South Coast Air Quality Management District

September 18, 2026

Draft Environmental Impact Report (EIR) for the Irwindale Brew Yard Specific Plan (Proposed Project) (SCH No: 2024020415)

Figure 1: Snapshot of Rail Segments on Proposed Project Site

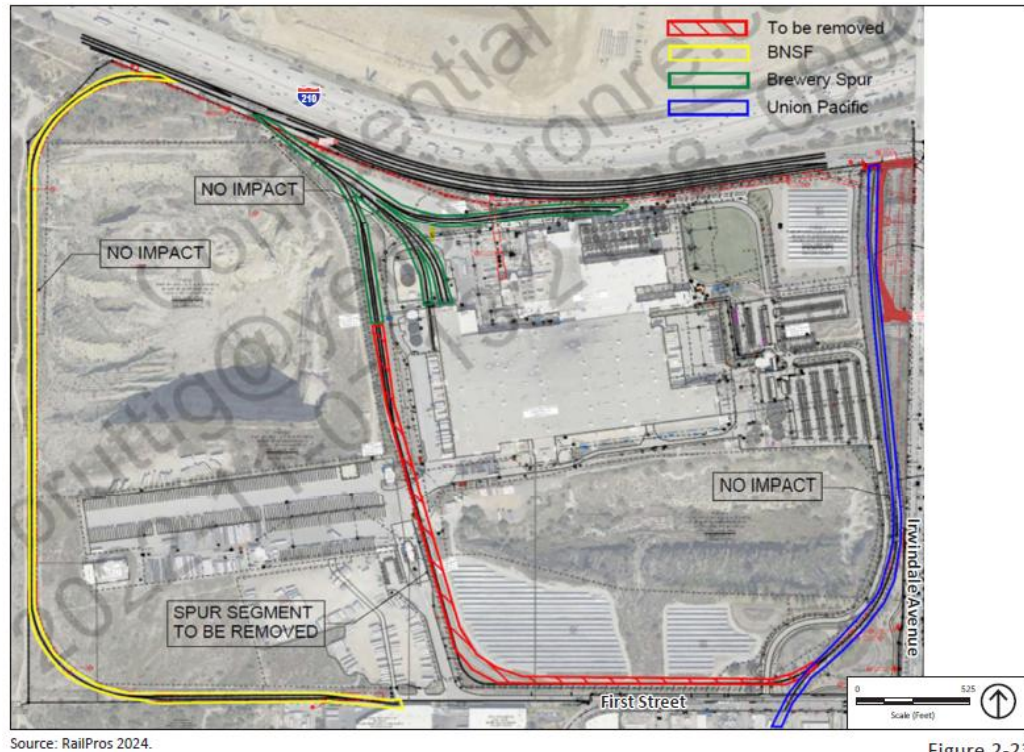
Chapter 2 (Project Description) of the Draft EIR indicates that implementation of the Proposed Project would require removal of an existing rail spur,¹⁴ identified in red, as shown in the snapshot of Figure 1 below. However, other rail tracks would remain onsite, including the Burlington Northern Santa Fe Railway (BNSF) track identified in yellow, the Brewery Spur in green, and the remaining UPRR track identified in blue.

The Draft EIR does not clearly disclose whether these remaining rail facilities would be used as part of the Proposed Project's operations, including whether goods would be transported to and from the Proposed Project site by rail in addition to truck trips. If the Proposed Project would utilize the remaining BNSF or UPRR rail facilities or share the Brewery Spur with the existing Brewery Yard Facility, emissions from locomotive activity, including train movements, idling, and switching, should be incorporated into the operational emissions inventory and HRA. In particular, diesel particulate matter (DPM) and other toxic air contaminants (TAC) emissions from rail operations should be evaluated for their potential contribution to cancer risk and non-cancer health impacts at nearby sensitive receptors.

Therefore, the Lead Agency is recommended to:

- 1) Clarify the Project Description to identify whether the Proposed Project would utilize the remaining BNSF and/or UPRR rail facilities for project-related goods movement;
- 2) Revise the air quality, GHG, and HRA analyses, as necessary, to include all reasonably foreseeable project-related rail emissions and clearly identify the rail activity, locomotive, idling, and emissions assumptions used in the modeling; and
- 3) Provide the revised emissions calculations, HRA results, and supporting documentation in the Final EIR to demonstrate that project-related rail emissions and associated health risks have been adequately disclosed and evaluated. If rail operations are excluded, the Final EIR should provide substantial evidence supporting that conclusion.
